MARIANO MARCOS STATE UNIVERSITY

BID BULLETIN No. 2022-022

Project: Establishment and/or Support to the College of Medicine (CO Component: COM Laboratory Building), MMSU-COM, City of Batac, Ilocos Norte

G/F REFLECTED CEILING PLAN
SCALE: 1:100 METERS

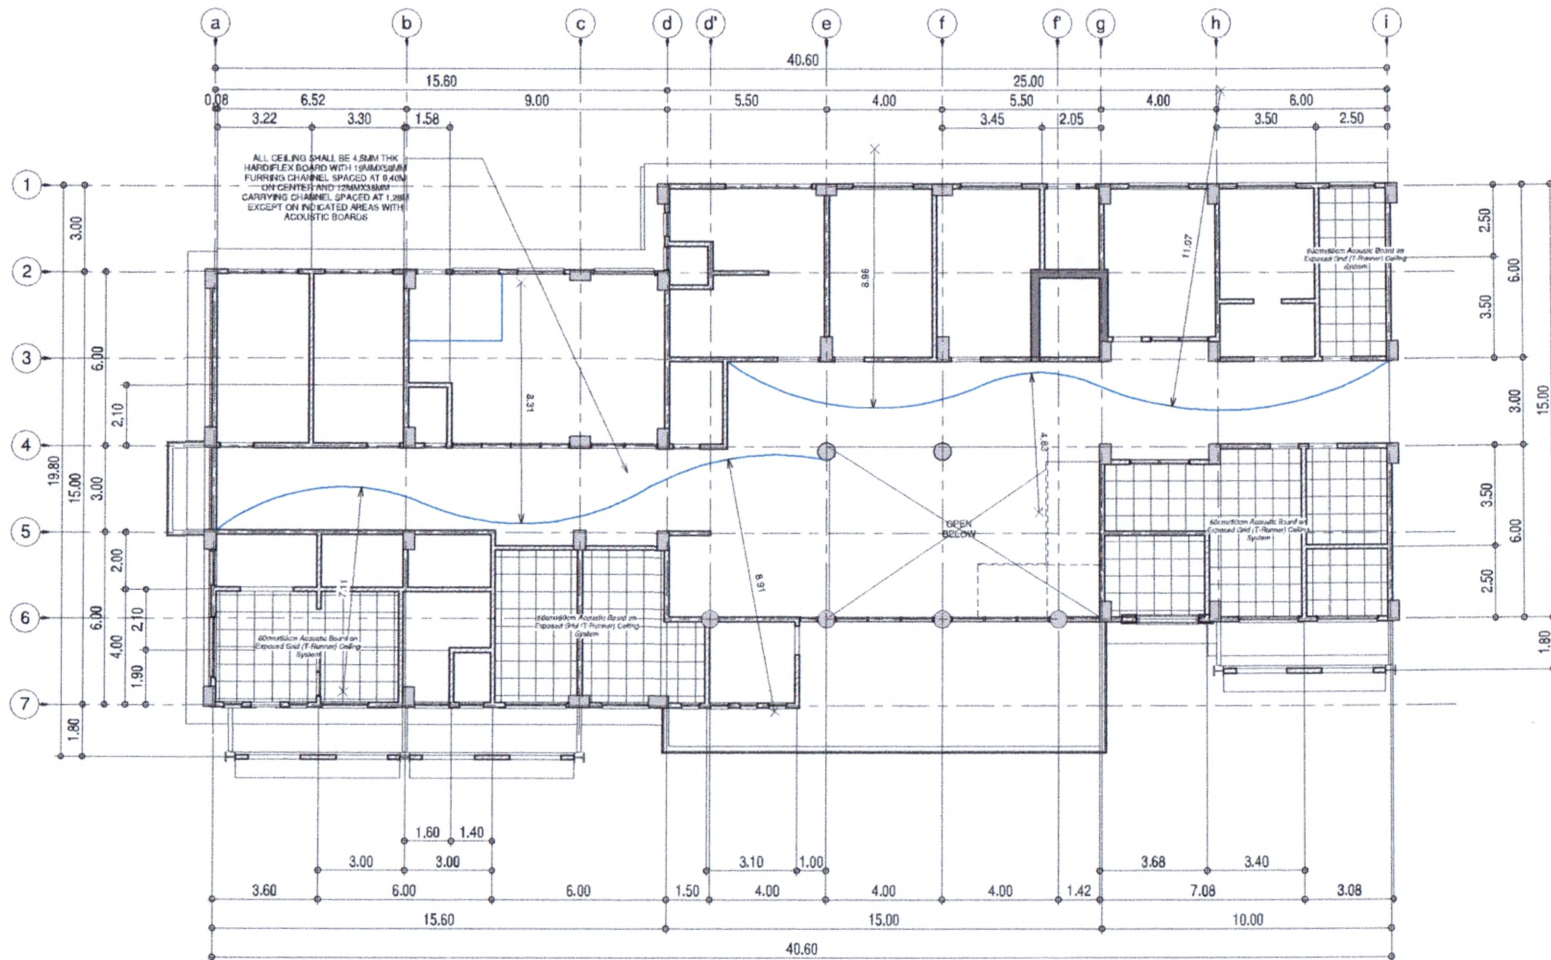
Specifications B.2, Reinforcing Steel	All reinforcing bars are Grade 40
Specifications C.17 & C.18	Rooms with acoustic board ceiling shall be TB DOTS Nurse area and waiting area. Laboratory room releasing, bacteriology and chemical chemistry. Extraction and pathology area. Radiology room office and ante room. The rest shall be hardiflex board on metal furring frame. Electrical Room and Utility Room has no ceiling. (See reflected ceiling plan)
Specifications C.20, Granite Tiles	Roofdeck is not included

2/F REFLECTED CEILING PLAN

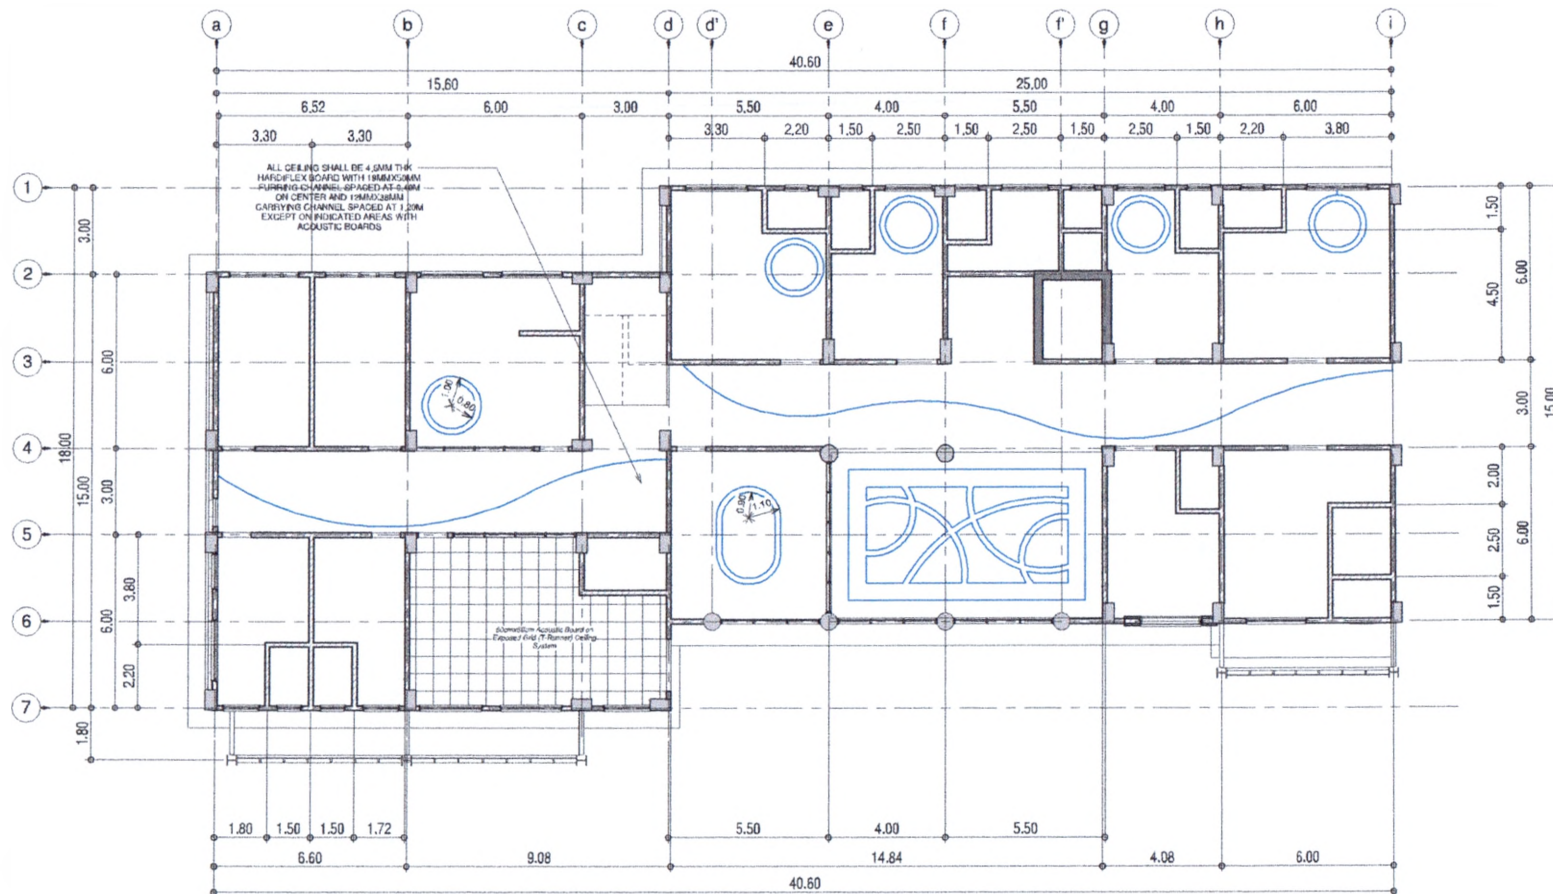
Specifications C.21, Water Proofings and cement base	Areas included are second floor comfort room, canopy at front and western exit balcony. The minimum number of coats is two but subject for flood testing.
Specifications, ceiling works	Ceiling shall be 4.5mm thk hardiflex board with 19mmx50mm Furring Channel spaced at 0.40m on center and 12mmx38mm Carrying Channel spaced at 1.20m on center. For 60cmx60cm Acoustic Boards, ceiling shall be on Exposed Grid (T-runner) ceiling system. (See reflected ceiling plan)
C.13 Metal Structures	Metal structure is removed
C.23 Water Source	Booster Pump and centrifugal pump is removed. Water supply shall be deep well with 2HP Jet pump and 82 gals pressure tank with complete accessories.
C.24 Plumbing Fixtures	4000 liters water tank is removed.
Detailed Estimated format	Detailed estimate shall be in DUPA format
